Approved MRE
12/22/23

EnvHealth/Environmental Health/Plan Check/Application

SFD/ INTERIOR ALTERATIONS TO Remodel of existing 2nd story primary bathroom.

DAVIS DWYER RESIDENCE
 INTERIOR RENOVATION
 1339 Ridgwood Dr Ellicott City, MD 21042

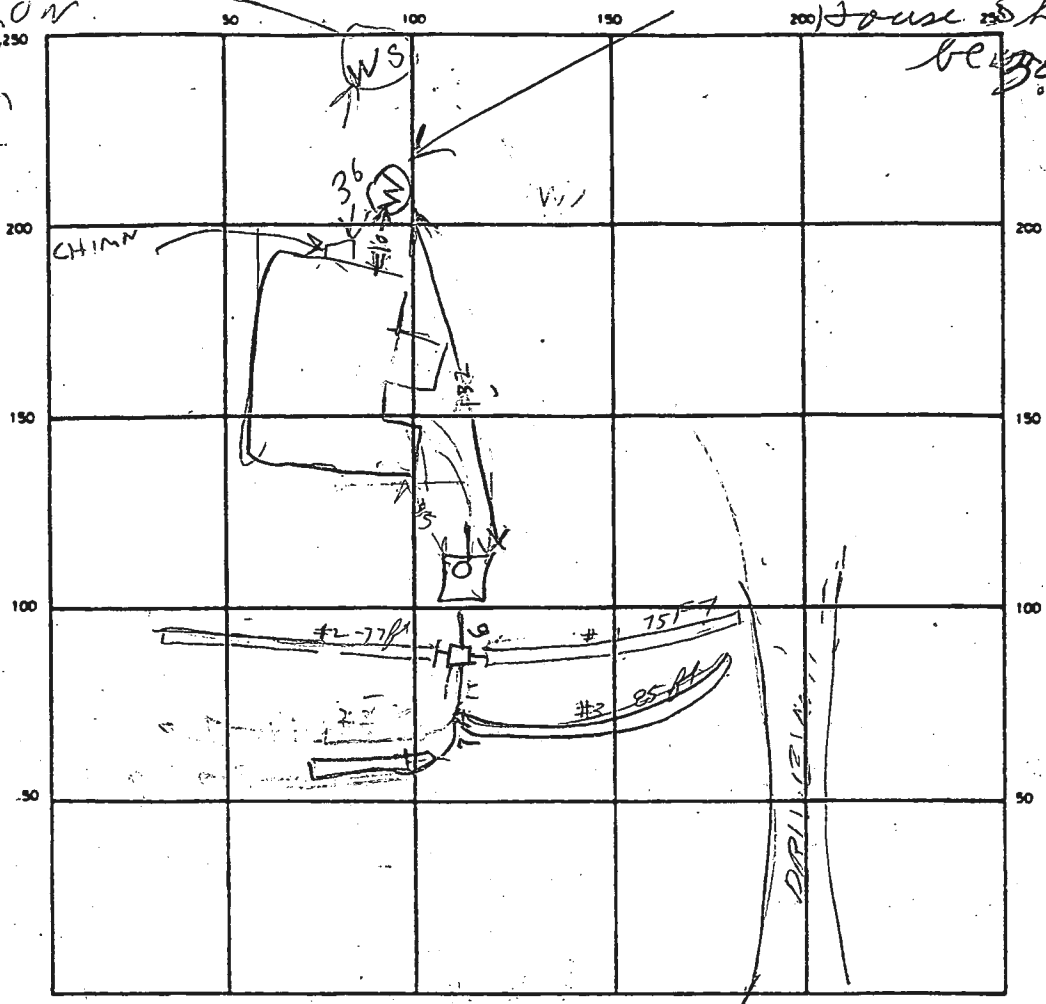
well too close to house should be back

REMARKS 10/17/90 LOCATION OK PER PLAN - WELL IS ONLY 10 FT

FROM HOUSE BUT 130 FT FROM TANK TALKED TO O SCHULTZ

MUST REVIEW WITH CW. TRENCHES NEED TO BE ONLY 240 FT LONG

& 3 FT WIDE 10/18/90 TRENCH #5 ELIMINATED TRENCH #4

SHORTENED TO 22 FT, TRENCHES STONE OK TO COVER TRENCH
